SUBJECT: Vac Ion

ATTACH. #2-B

SUBJECT: Vac Ion Power

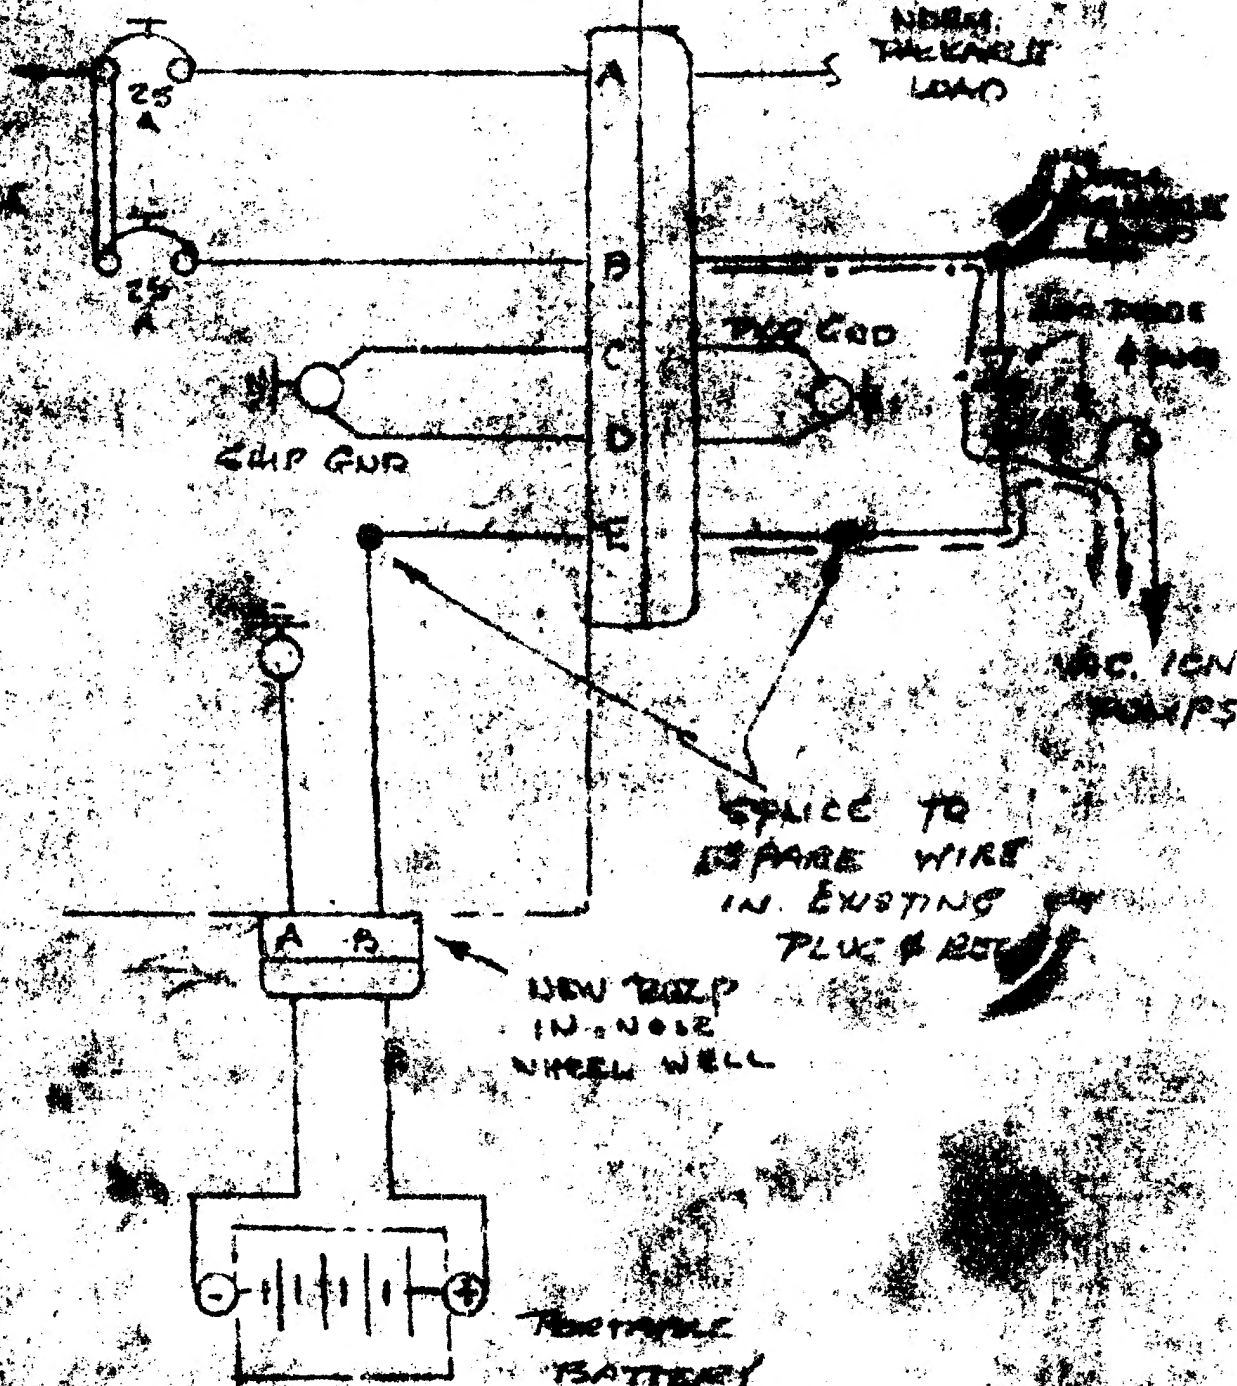
I have reviewed the note from [REDACTED] dated September 18, 1963 and have the following comments:

a. We would like to eliminate the fuse between the diode and the vac ion power supply as is suggested since it would increase our reliability. Unless there is some objection from the vehicle people, which we don't foresee, we will omit this fuse.

b. We would like to know the type of connector they are planning to use in the wheel well so that we can make up our battery and harness to mate.

c. [REDACTED] will assume the responsibility of making the necessary changes in our harness (on the package side of Q5) to accommodate the diode and "E" wire. He will make up a suitable jumper harness so that the vac ion supplies will run without the system package.

d. My Group will supply the portable battery and necessary harness connectors to mate with the connector in the wheel well.

} afraid
of back
flow thru
relays, ok
Keep Diode,
eliminate
fuse
